RECEIVE AND FILE COMMUNICATION FROM THE PLAN AND ZONING COMMISSION REGARDING APPROVAL OF A PRELIMINARY SUBDIVISION PLAT FOR "GRANDVIEW MEADOWS" DEVELOPMENT ON PROPERTY LOCATED AT 4301 GRANDVIEW AVENUE

RE: Preliminary Plat, Bloomfield Acres/Grandview Meadows  
13-16-1.14

# PRELIMINARY PLAT GRANDVIEW MEADOWS

SHEET  
4 OF 4

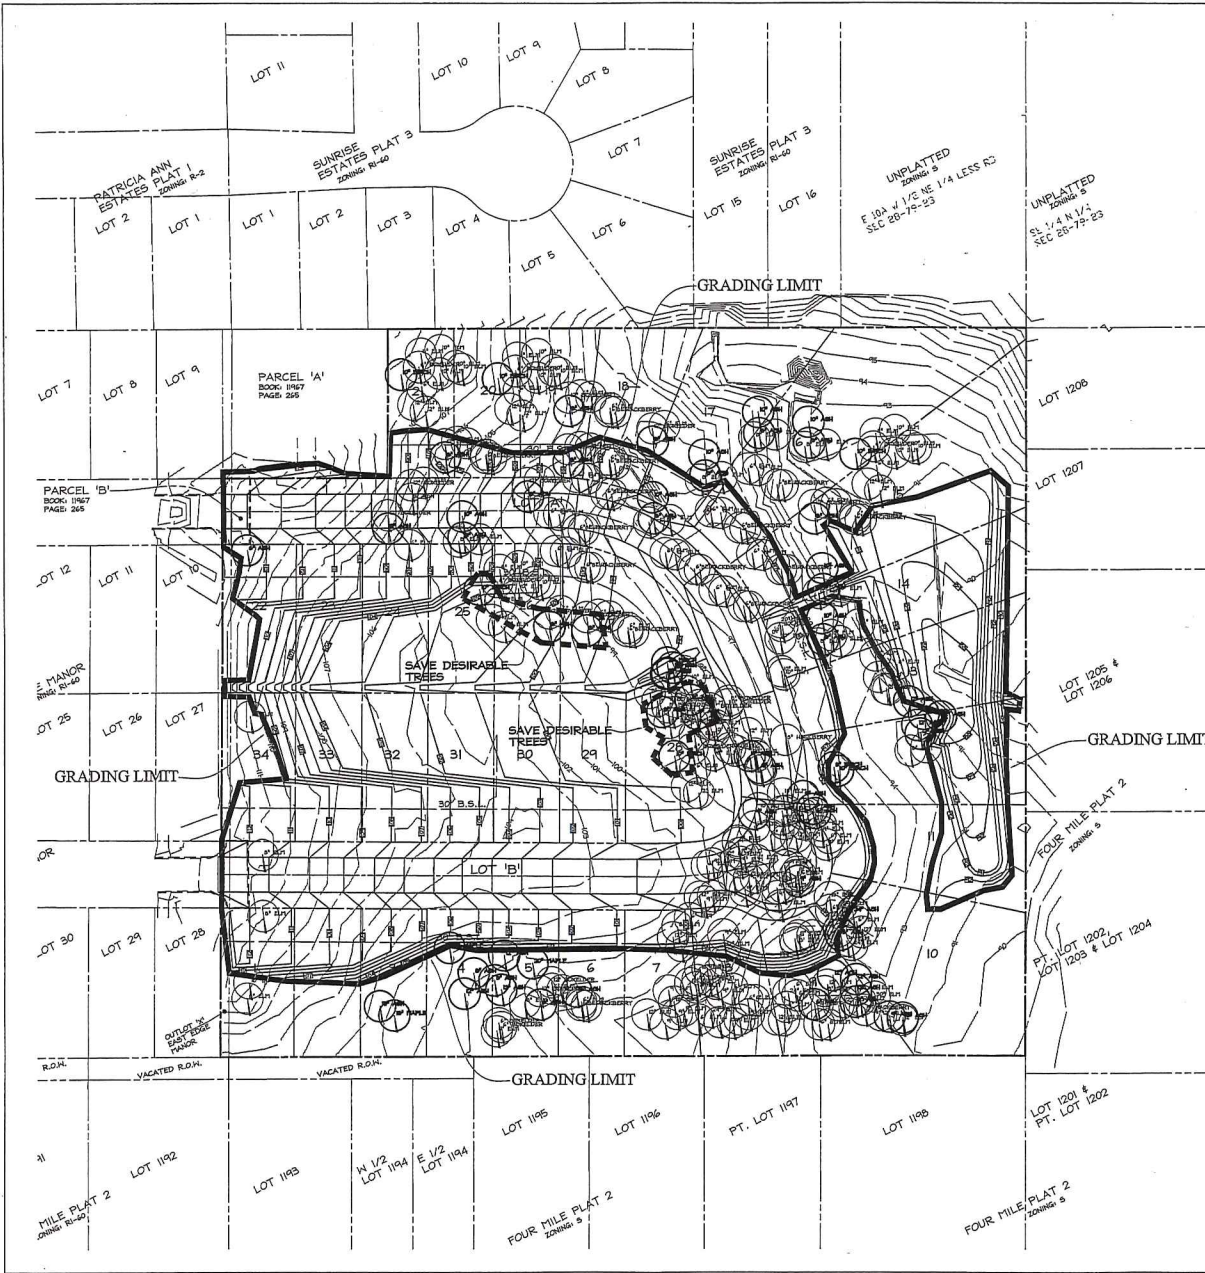
3. Provide a detail of the proposed outlet structure(s) on the plat. The detail should specify the elevation and sizes of the pipes/ orifices.
4. The temporary sediment basin detail on the plat shows a 15" outlet pipe. The Stormwater Report notes that this as a 12" pipe. The plan view on the plat shows this as a 10" pipe. Please define a size for this outlet pipe.

5. Per SUDAS 2A-4, the Stormwater Report must show analysis of the 2-yr existing vs 2-yr proposed peak flow storm events. We have concerns that this "intermediate" event will

not be detained very well given the size of the basin's large outlet pipe. You may need to include a multi-stage outlet structure (recommended) or a third outlet pipe to satisfy this requirement.

6. It may be desirable to route offsite flows from the north and northeast around the proposed detention basin such that they are bypassed.
7. The proposed detention calculations in Part 3 (Detention Analysis) appear to have been done assuming HSG Type A soils. This should be changed to Type B soils to match the existing condition calculations and the Geotechnical Report analysis.

8. The desired width of storm sewer easements has changed since this plat was originally submitted back in 2007. The absolute minimum width on any one side of a public storm sewer that is not located in the ROW is 10 feet (measured from the center of pipe). The minimum total width is 30 feet. The easement between Lots 11 & 12 should be increased in width 2.5' (minimum) on the north side to meet this requirement.

9. The 10' width minimum requirement also applies to storm sewer located in the ROW that is within 10' of a property line (measured from the center of pipe). Exceptions can be made if the distance is just under 10' and the length of pipe that is under 10' from the property line is minimal.

12. Please revise the name of the plat. Bloomfield Acres has already been assigned to another plat. The previously submitted name of Grandview Meadows is available.
13. Identify the cluster mailbox location(s) on the plat.
14. Change the sidewalk width in note 1 to 5 ft.
15. The sanitary sewer at lots 11 and 12 does not continue east past the angle. Remove the solid line extending it to the edge of the plat.
16. Ownership or consent to plat for all parcels within the boundaries of this subdivision will be required to approve the plat.
17. Please verify the trees to be removed on site. While the tree mitigation calculations submitted are sufficient, it seems that additional trees may need to be removed for grading

and construction activities. The current tree removal and mitigation standards do provide for an alternate canopy option requiring (1) tree for every 2,000 sq ft of canopy removed.
